ADDENDUM TO INITIAL STUDY/ MITIGATED NEGATIVE DECLARATION (SCH No. 2020059026)

SAN MATEO UNION HIGH SCHOOL DISTRICT MILLS HIGH SCHOOL ATHLETICS COMPLEX PROJECT

April 2021

This Addendum addresses refinements to the project's light impacts analysis. As demonstrated in this Addendum, the IS/MND continues to serve as the appropriate document addressing the environmental impacts of these improvements pursuant to California Environmental Quality Act (CEQA).

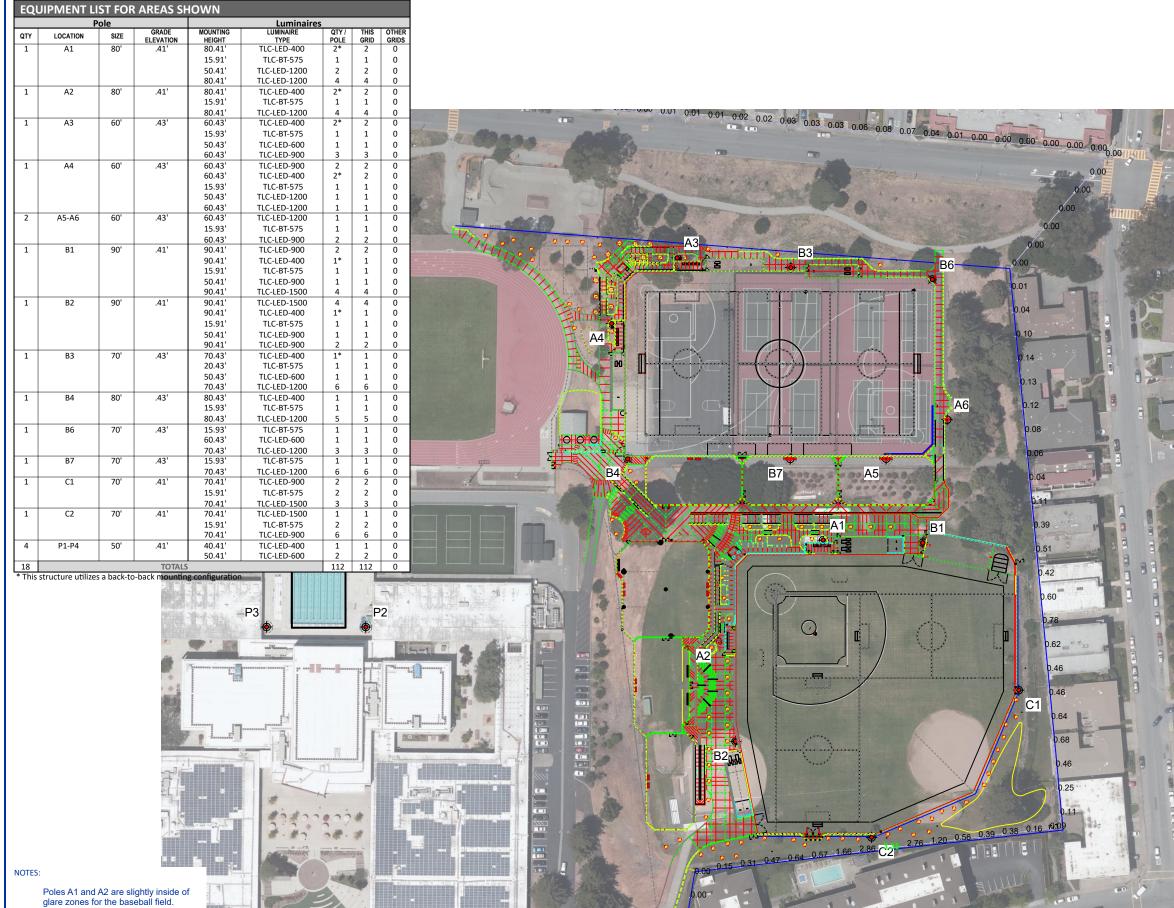
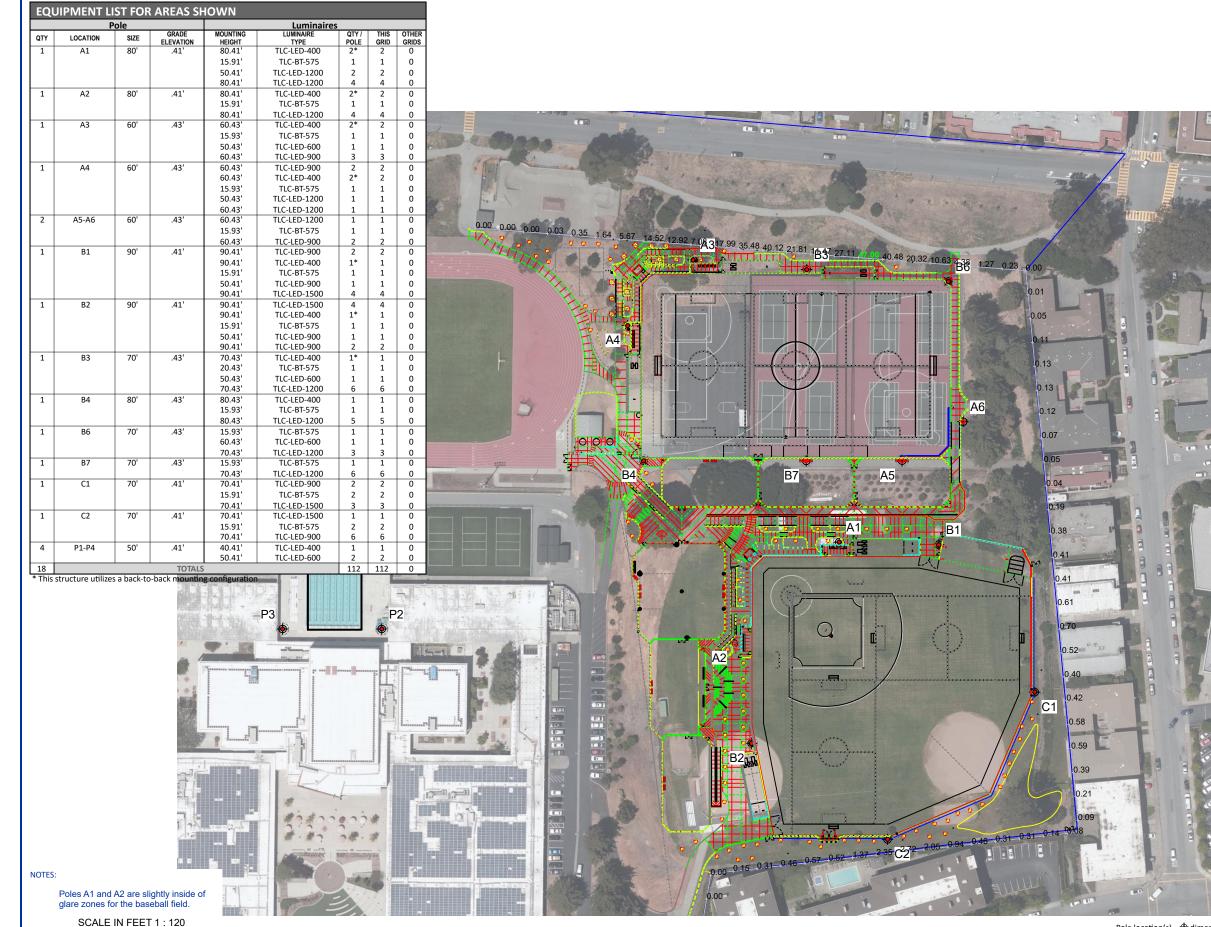
Adjustments were made to the lighting plan and a refined glare light and impact analysis was conducted for the project (Attachment 1 to this Addendum). That analysis concluded that the IS glare impact analysis overstated the off-site glare values of these projects. That analysis was based a 2D model that shows values at the grade of the field(s) (i.e., on the field itself) and does not consider glare above or below this grade, such as at the elevations of the adjacent residential properties. At the site, there are residential properties that are either at a higher elevation than the field (thus looking down at the field), or a lower elevation than the field (thus looking up at the field). In order to address this deficiency, Musco added linear grids that follow along the residential property lines. These grids address the varied elevations along these lines as well, thus offering more accurate light and glare impact numbers. The measurements shown along the residential property lines are taken at $+3^{2}$ relative to the grade elevation, which is the standard for where light readings are taken. Per the latest Musco plans and analysis, the highest candela reading at the property lines adjacent to the Mills fields would be 8,644 candela, far below the 25,000-candela standard used in the IS, and also below the more conservative 10,000-candela threshold used in this Addendum.

In summation, the project would have lower off-site glare than that described in the IS, and would conform with both the IS's 25,000 candela and the new 10,000 candela significance thresholds. Therefore the impact would be less than significant and Mitigation Measure AES-1 is no longer required. That measure has been removed from the IS and the Mitigation Monitoring and Reporting Program for the project (Attachment 2 to this Addendum). Further, the last three sentences of the IS text above have been revised to read as follows:

A detailed analysis of light and glare at the property line at a height of 3 feet above the ground surface indicates that the residents located adjacent to the baseball field would be exposed to glare of about 8650 candela, which would result in **less-than-significant** glare impacts. No mitigation is required.
